# **Attachment A**

## **Building Envelope Modification Design Report**

Henning Larsen Architects have prepared a detailed building design for the Cockle Bay Park development as part of the application.

## Crescent Garden

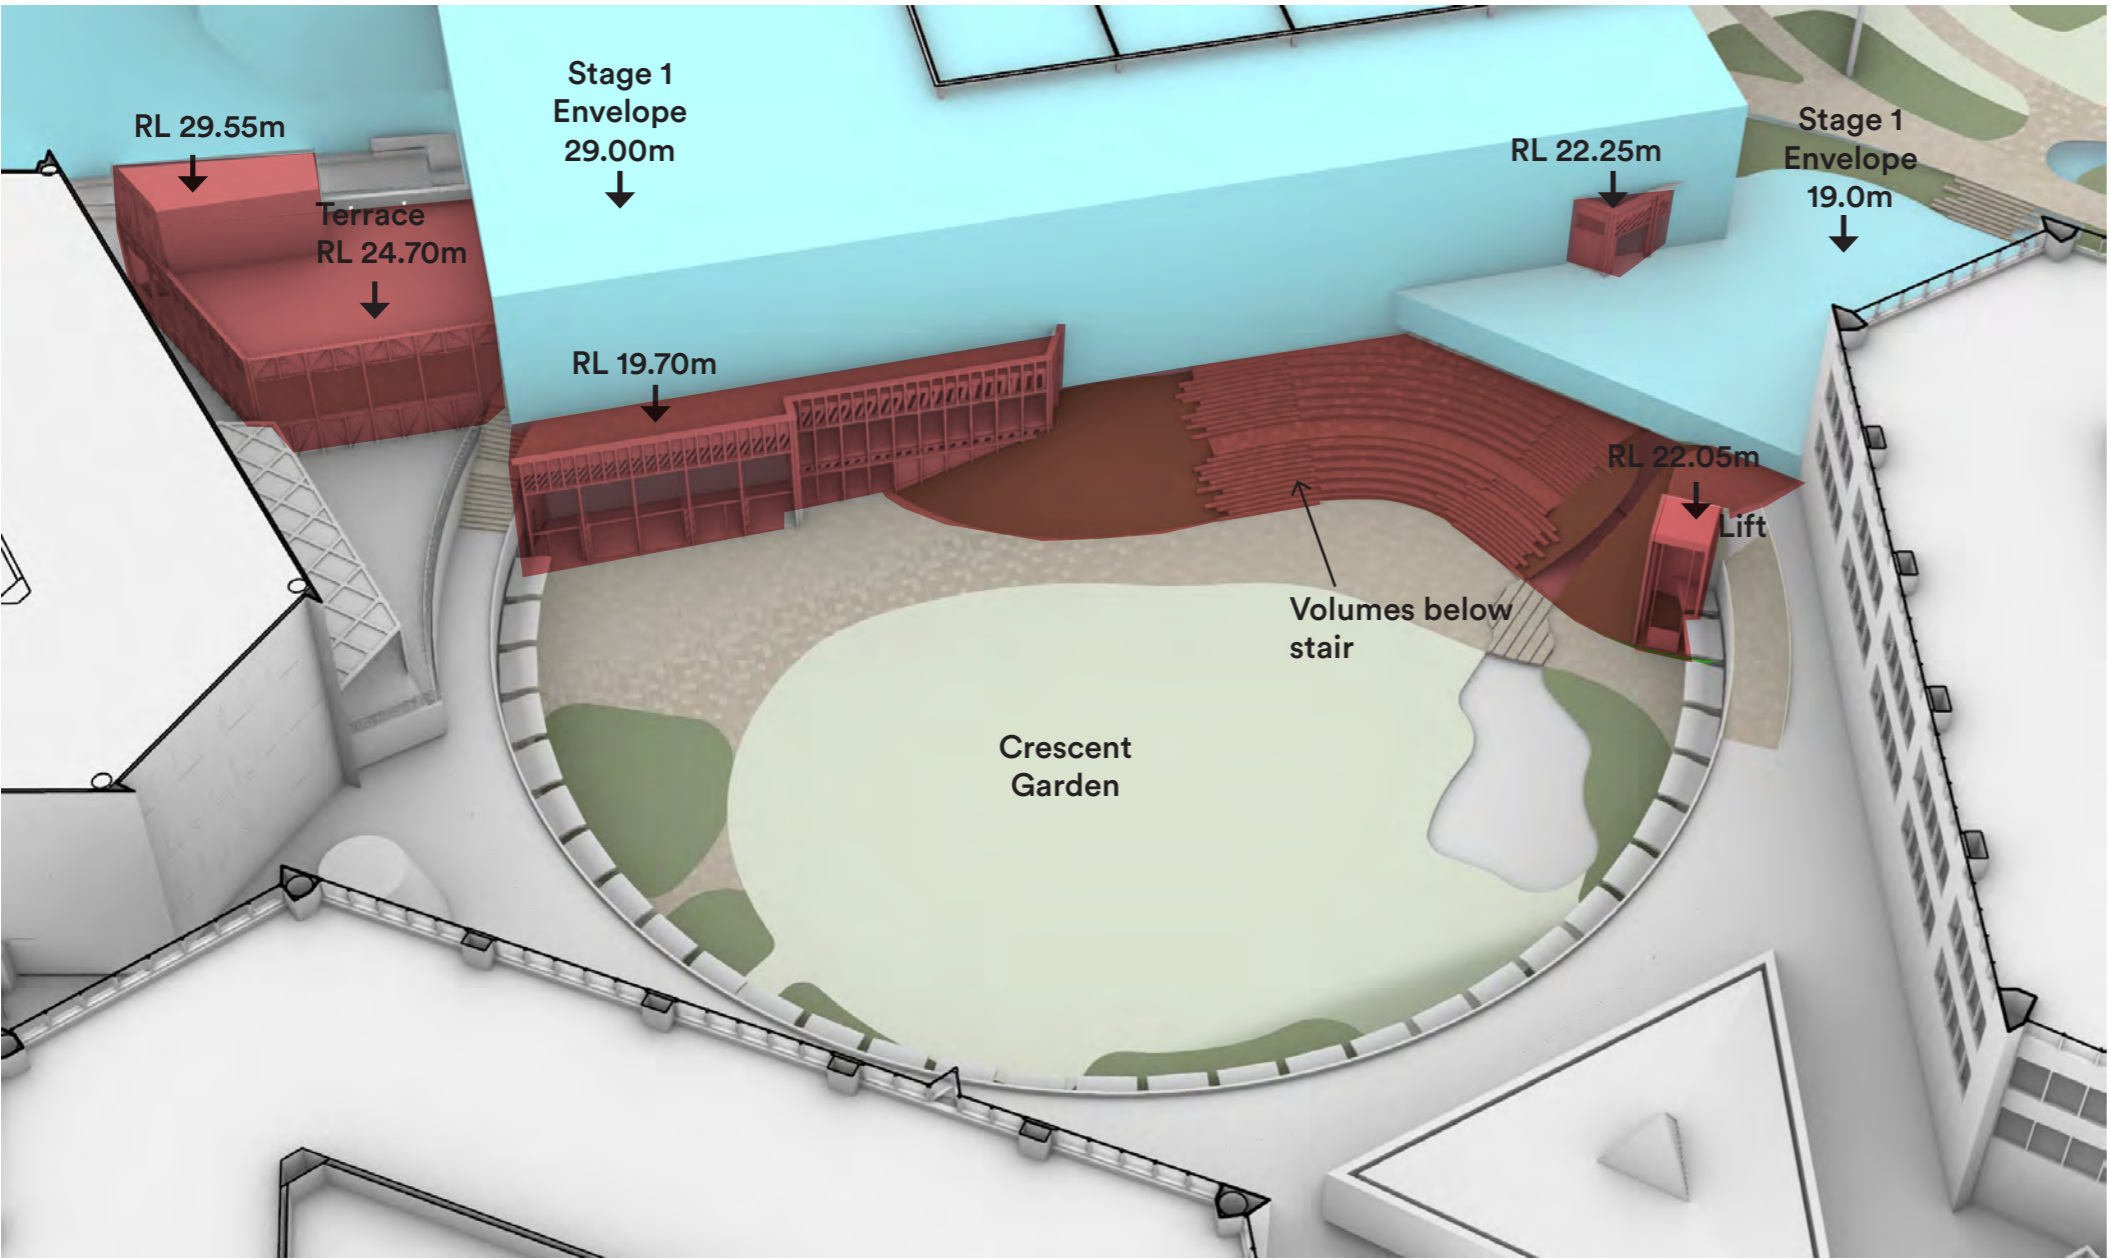
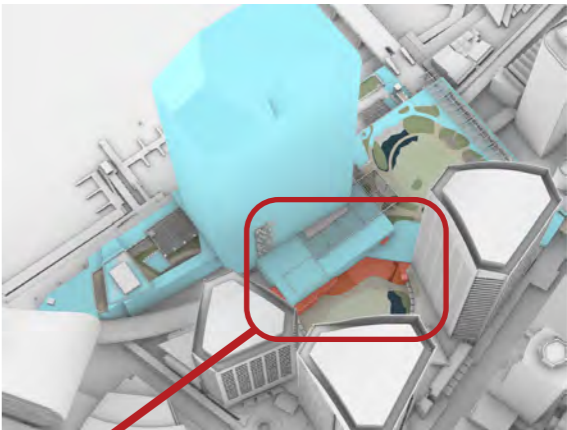
The updated scheme is proposed to include connections from the new Tower to the Crescent Garden open space and the Darling Park precinct.

The configuration of these volumes enables seamless integration with the existing Darling Park built form and brings a village typology of volumes to crescent garden.

The setting out arrangement and extents of the volumes has been guided by the structural grid of the existing building below. It will also achieve the natural

amphitheater envisaged for this space in the adopted Design Guidelines.

## Tower (East)

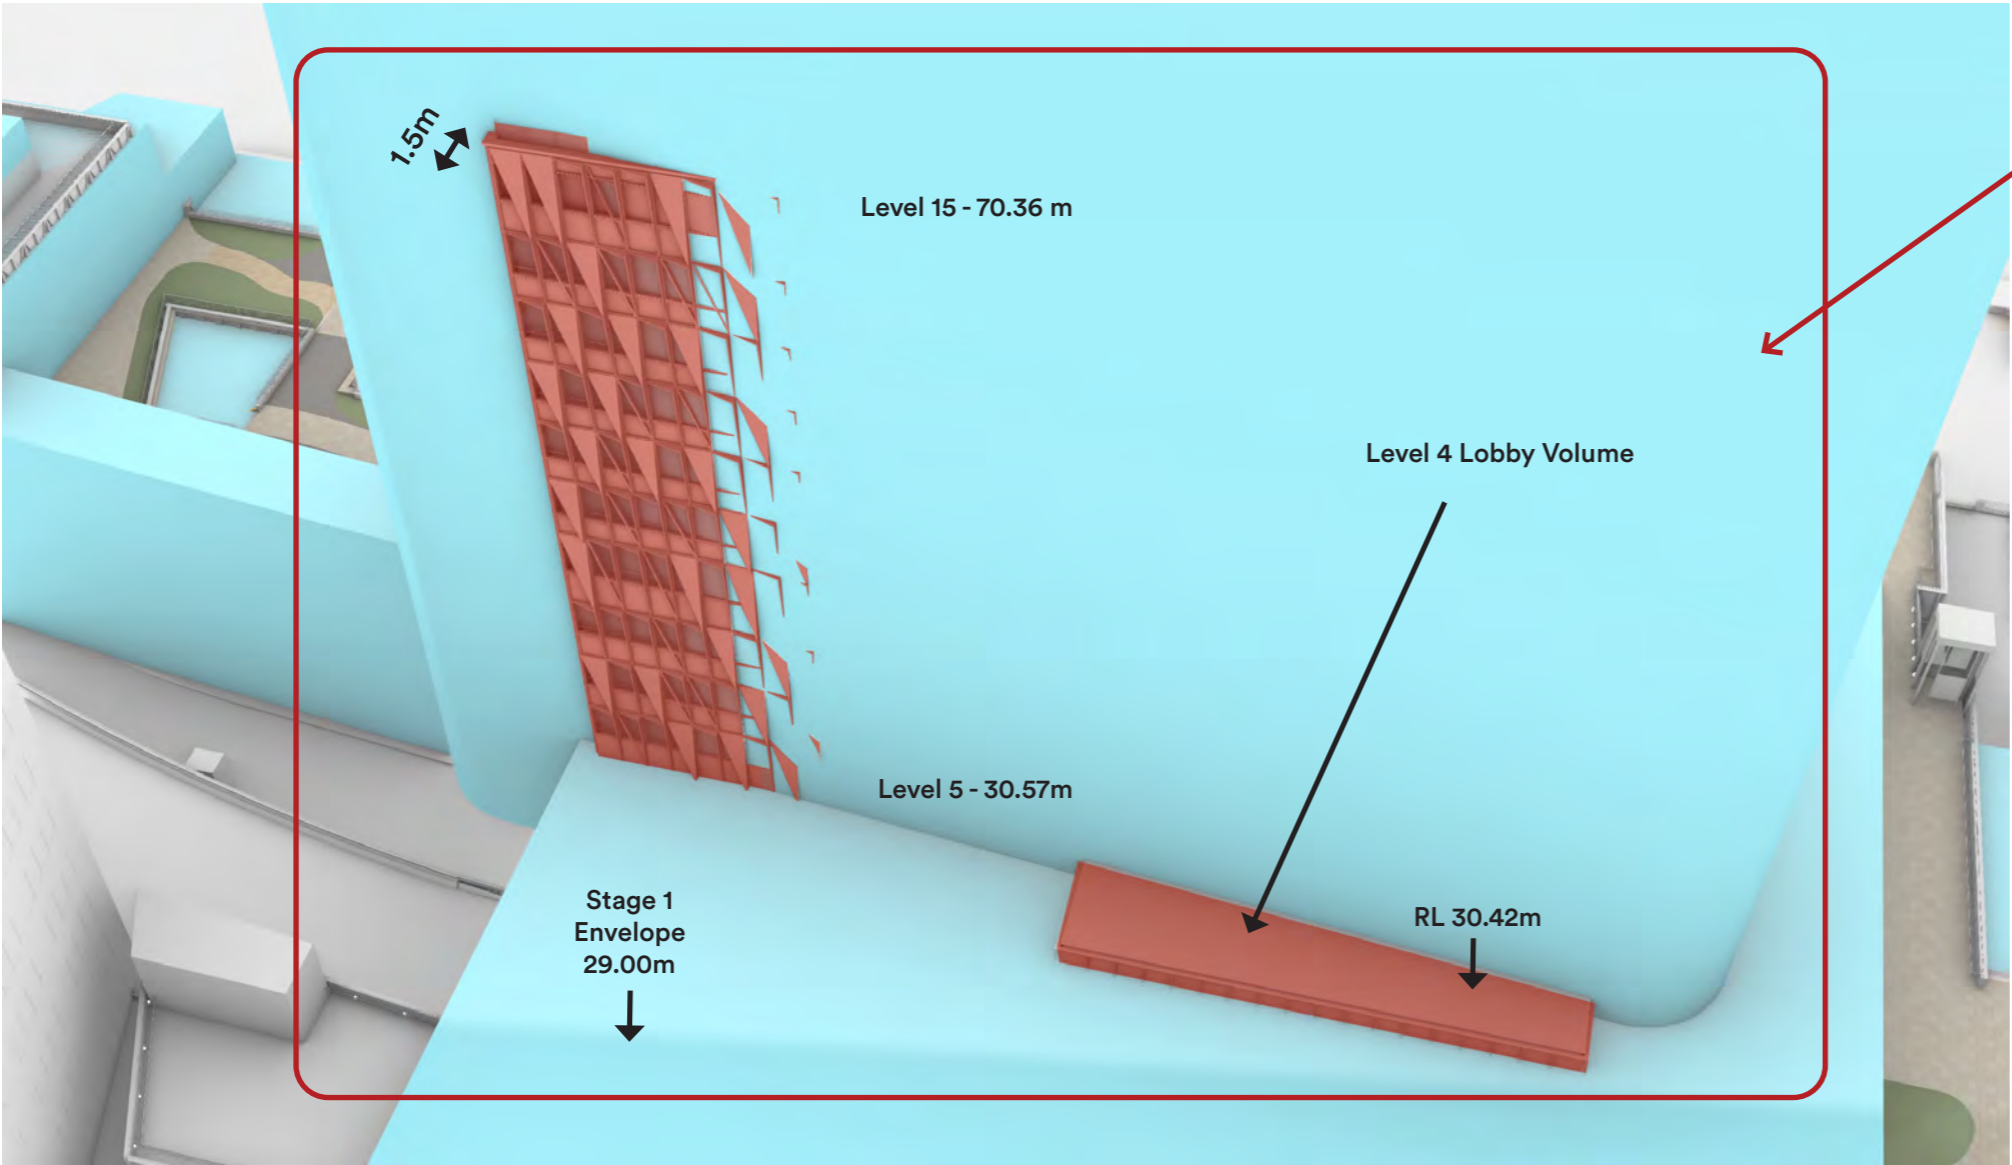
While the concurrent Stage 2 SSD DA built form has pulled back from the envelope in many areas. The building envelope is required to be modified on the low-rise eastern facade to account for an adjusted footprint of the building to provide better tower articulation, and to optimise modulation of the facade elements.

A portion of the Tower on Level 4 breaches the envelope to the North-east - a result of the raised level of the Tower Lobby on Level 3 below. This envelope breach is deemed to be minor and appropriate.

**Outside the envelope:**  
1m - measured to the facade's glass line  
1.375mm - including facade's shading elements

# Tower - Retail Pergolas

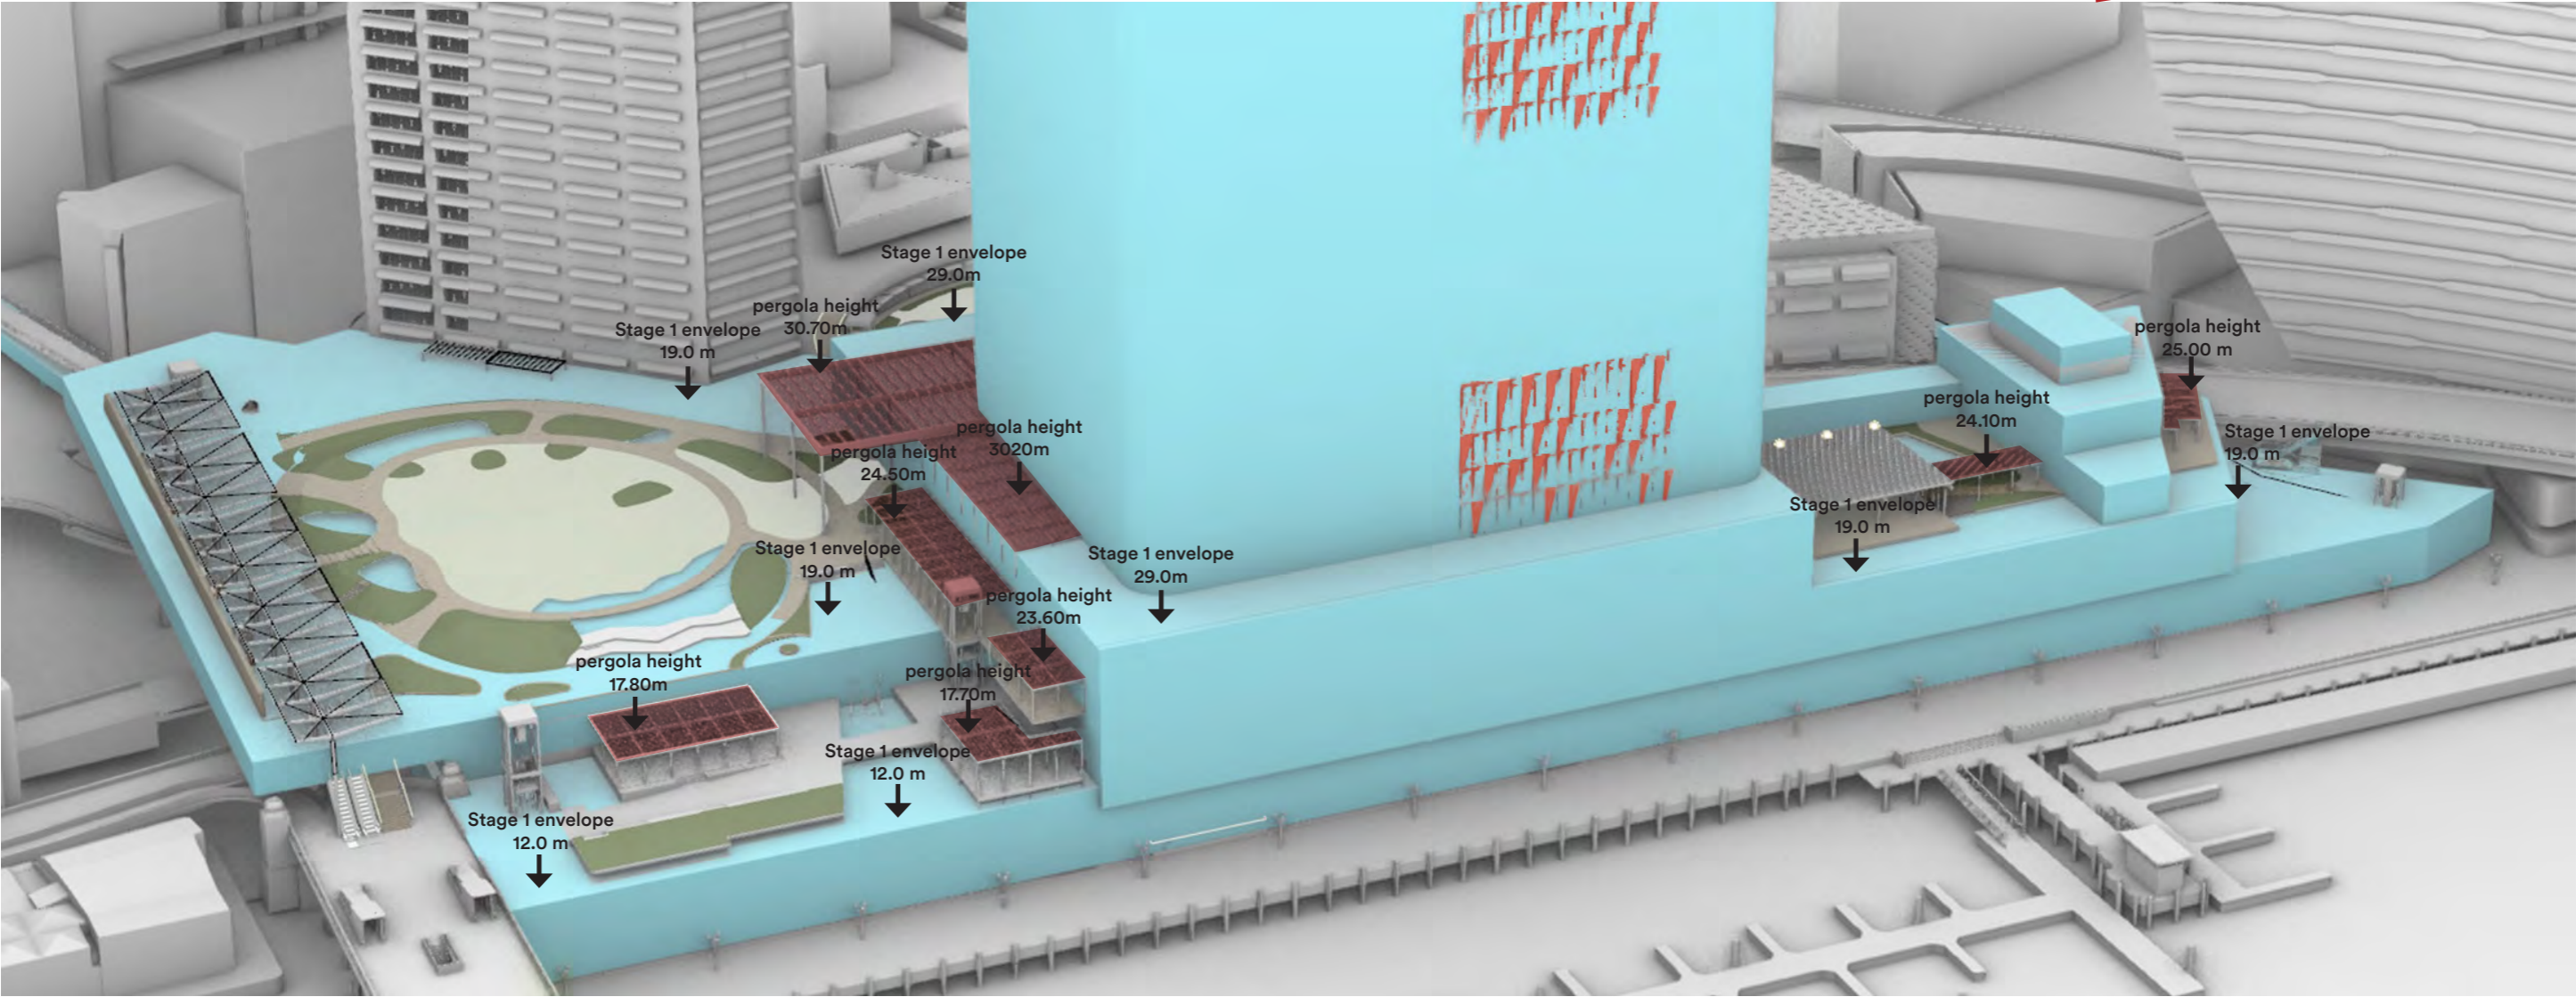
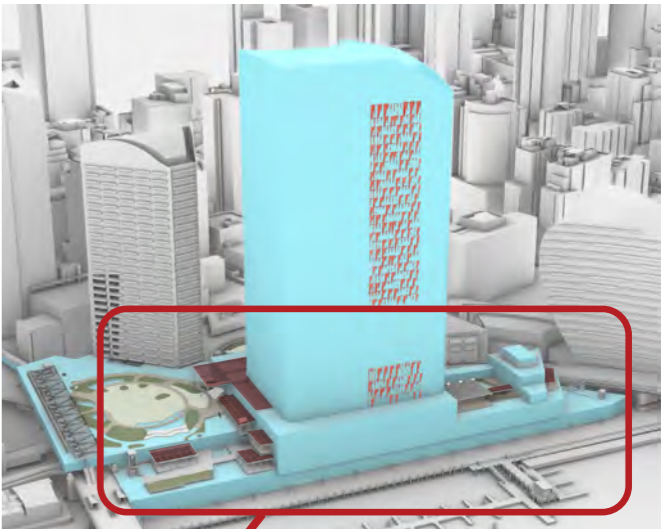
The Concept (Stage 1) DA permits garden pavilions and kiosks beyond the building envelope where these components are within, and relate specifically to, the publicly accessible open space or the public domain. The proposed pergolas are associated with the northern and southern park spaces and, therefore, are aligned with publicly accessible open space and public domain areas. In the case of the pergolas within the public domain, these refinements, therefore, would fall within the permitted exemptions and are appropriate and supportable.

Other pergolas around the base of the Tower provide much needed solar shading and climate comfort to external areas. They also shelter vertical transport elements, such as escalators, from the rain. The pergolas close to the Tower help to reduce down draught from winds around the Tower.

# Compliance Clarification: Tower (West)

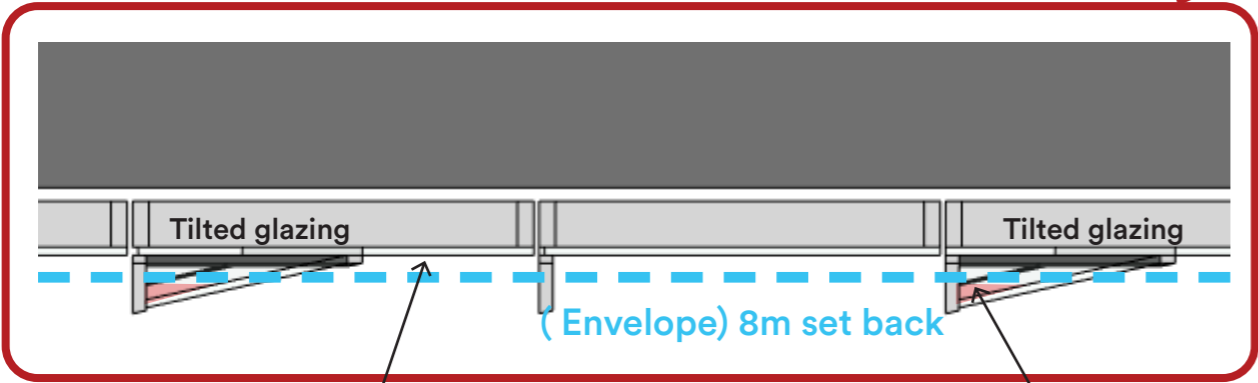
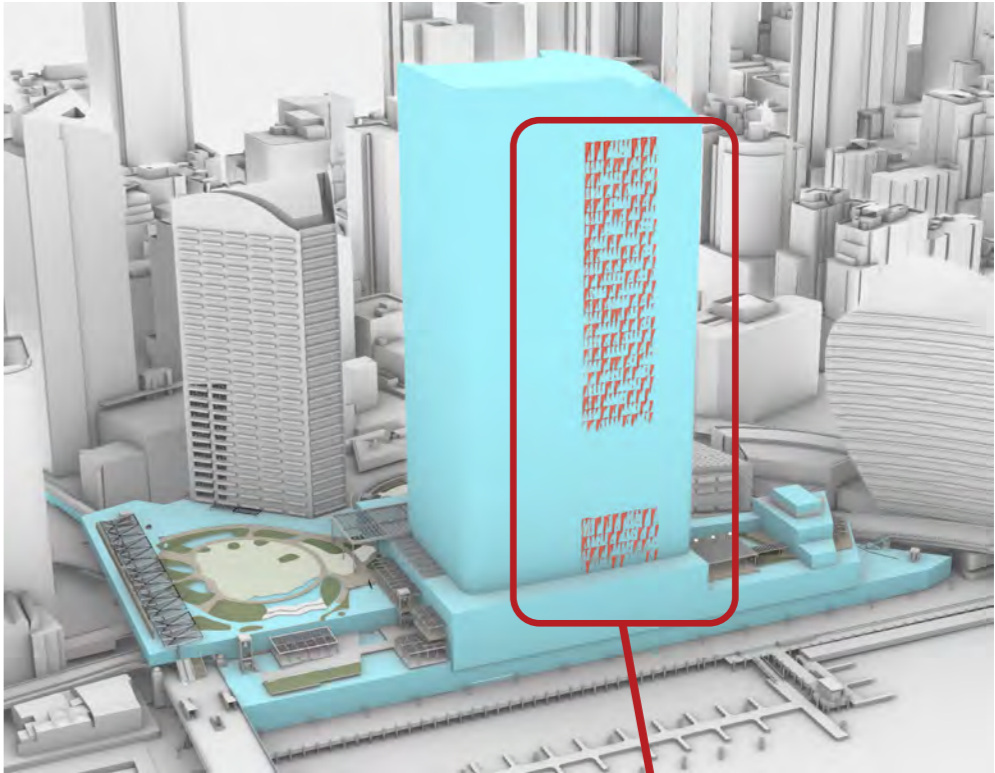
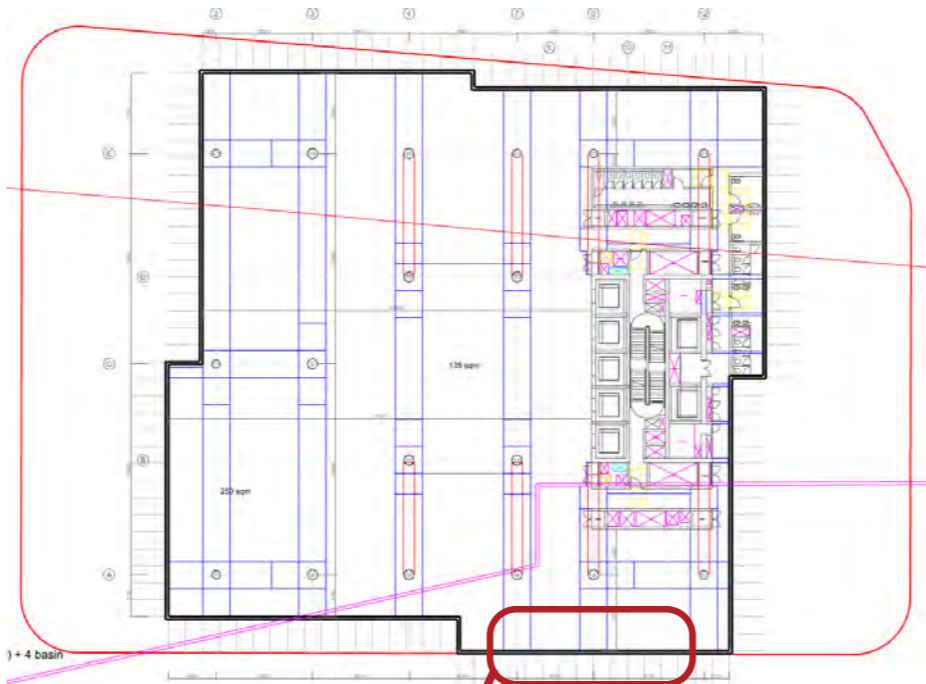
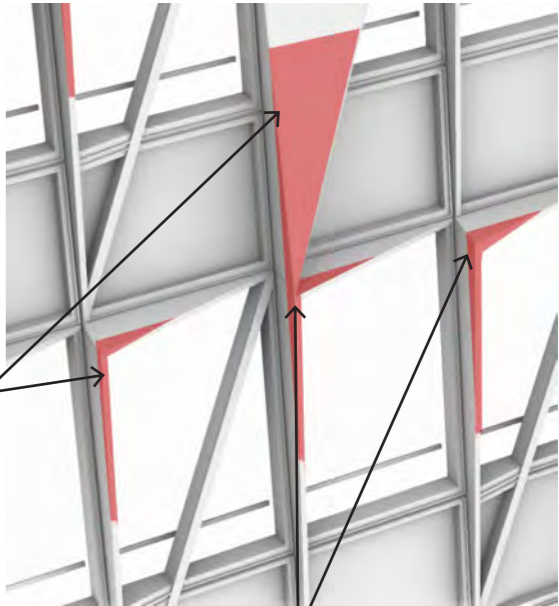
Currently in the the Western facade, a small portion of the facade articulation elements extend outside the envelope.

The proposed Tower facade elements that extend past the envelope are minor and variable, and do not constitute GFA. This articulation of the facade is an improved design outcome, optimises modulation of the facade elements and reduces heat gain in the tower.

Facade's shading elements extend through the envelope by approx. 200mm

Aluminium inclined triangulated opaque infill spandrels slightly outside the envelope.
